## Cannondale Motorsports Service Bulletin

BULLETIN : SB02-006

MODELS : 2002 C440 up to and including VIN 5B6BC21C32B000115

SUBJECT : Incorrect routing, steering head

## C440 CORRECT ROUTING (STEERING HEAD)

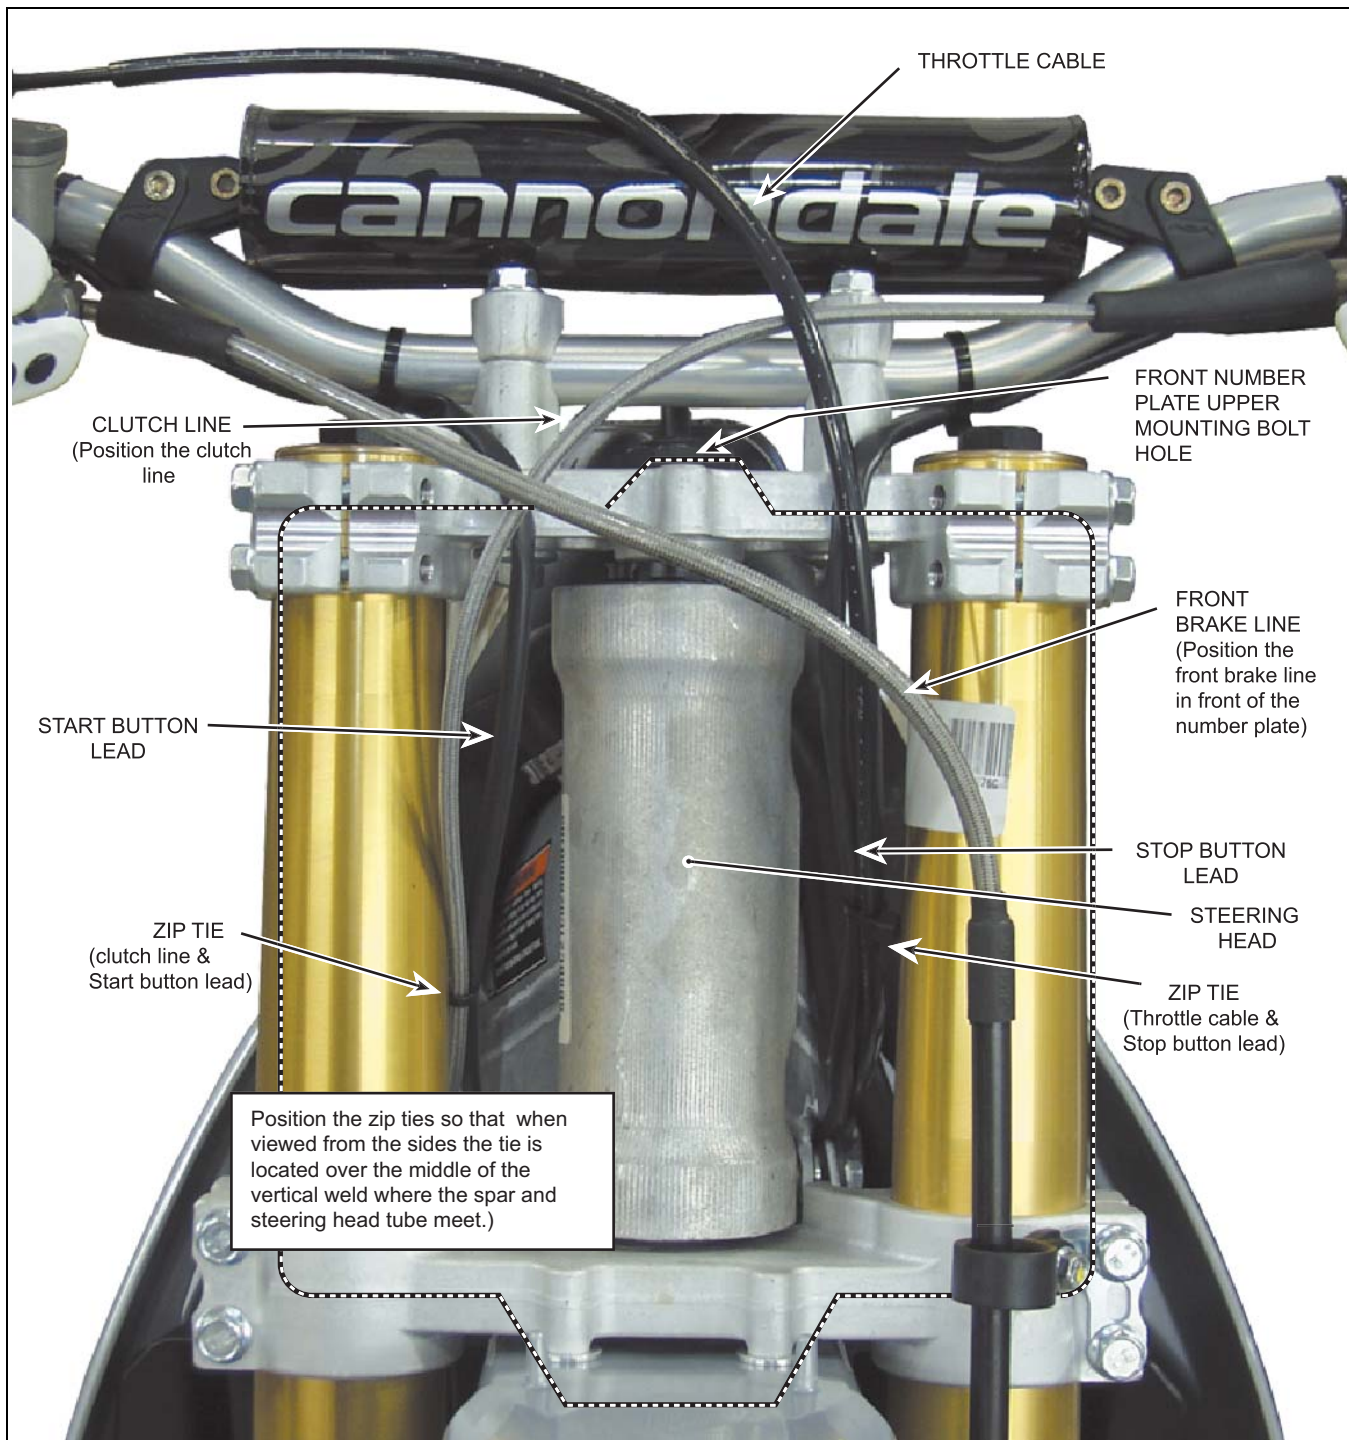
CONDITION : The front number plate on a small number of C440s was installed so that the throttle cable and front brake line were routed on the wrong sides of the small tab holding the number plate to the upper triple clamp. This routing of throttle cable and front brake line is incorrect and can result in damage to the throttle cable and/or front brake line.

The photo above shows the correct routing and identity of the cables and lines in the steering head area. The front number plate (represented by the dotted line ) has been removed in this photo for clarity.

*The front brake line is routed in front of the installed front number plate.*

*Notice the location of the upper front number panel mounting hole in the upper triple clamp.*

SOLUTION : Inspect that the front number plate is mounted with the throttle cable on the vehicle left side of the upper plate mounting tab and make sure the front brake line is on the vehicle right side of the mounting tab. See "C440 Correct Routing (Steering Head)" on page 2 of this service bulletin. Correct the routing if necessary. Remove the front number plate upper mounting bolt and position each cable as indicated in the illustration. If the cables were routed incorrectly, thoroughly inspect the cables and harness leads for any damage that might have occurred (e.g, bending, kinks, pinching or abrasion) and take corrective action. Reinstall the upper front number panel bolt when complete. Check the vehicle controls for proper function.
